Application Number: 10/784,459
Filing Date: February 23, 2004
Appellant(s): WEBB ET AL.

EXAMINER'S ANSWER

"B"

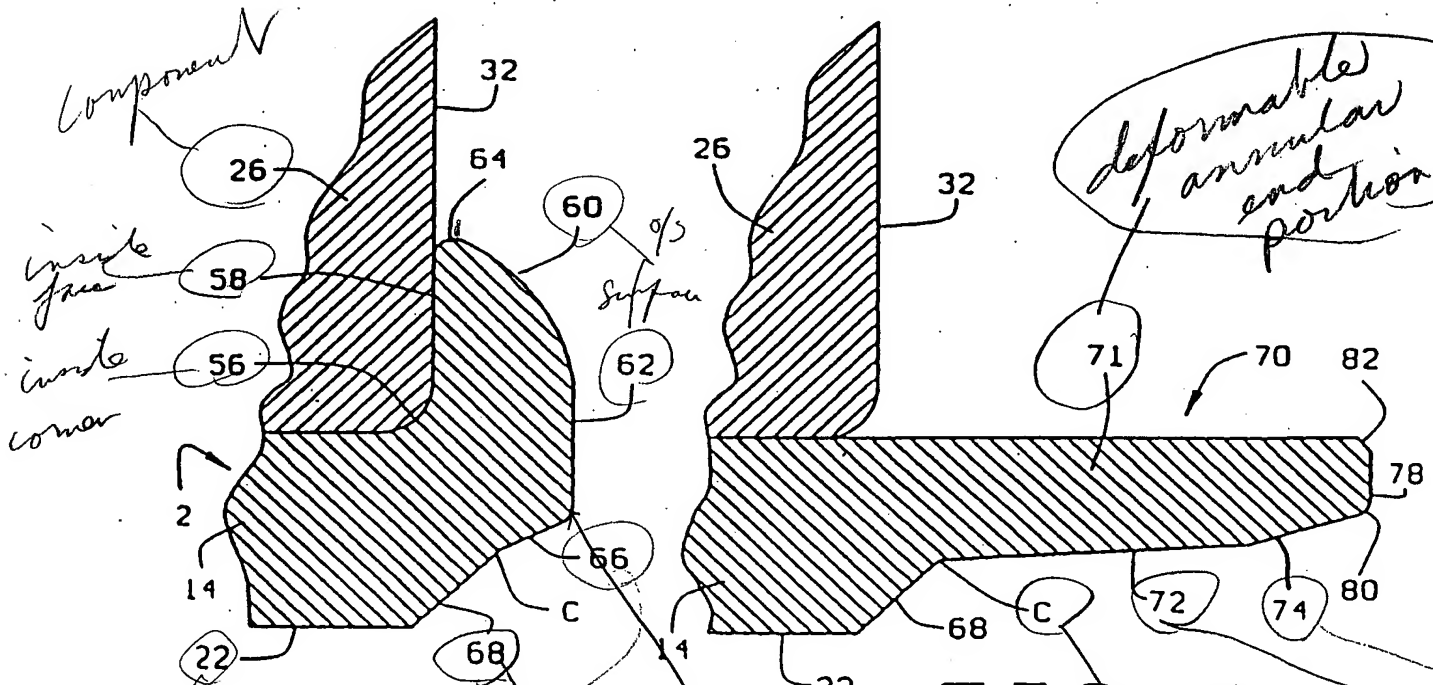
Considering claim 61, and making reference to attached exhibit "A" (a marked-up copy of fig. 3 of Hofmann [on front page]), and exhibits "B" and "C" (marked up copies of

appellants' fig's. 3 and 4; and fig. 1, respectively) the indefiniteness of claim 61 and extent to which Hofmann reads upon the finished product may be considered. Because of the detail involved, and the necessity of description of some features with explanatory markings, reference to these exhibits is suggested as opposed to the unmarked figures.

Claim 61 calls for a "spindle" 14 having a "component" 26 (inner race) "secured thereto by a formed end" 20. (Note that appellants' fig. 3 formed end, which is the same as that in fig. 1, appears to differ slightly in shape. This is put down to the fact that fig. 1's formed end is illustrated in smaller form which would make complete detail more difficult; therefore references to the more detailed and referenced fig. 3 will control, there being no confusion as to the appellants' intent in this regard.) Unless otherwise indicated, all references to Hofmann will be to marked-up fig. 3.

The "formed end" makes clear that the claim refers to the finished product of fig. 3 as opposed to the undeformed perform of fig. 4. Hofmann fig. 3 shows a spindle and component secured by a formed end.

Claim 61 then calls for a "spindle outer surface ... and ... deformable end portion (71) with an outer end (78)", which is where the trouble begins because we are now talking about the perform of fig. 4, which is not present in the finished product, contradicts the finished product, and the detailed particulars of which in their transmuted finished form (e.g. end 78) can only be guessed at. "As understood", preform features

The claimed spindle has a beveled surface 68 inclined inwardly from the end – see marked area of Hofmann.

curved outside surface of the formed end starts its curve while it is still moving outwardly and then, after reaching its maximum outward point, starts curving axially inwardly. Note that appellants' fig. 3 also shows a marked "second curved surface" where surface 62 transitions to surface 66.
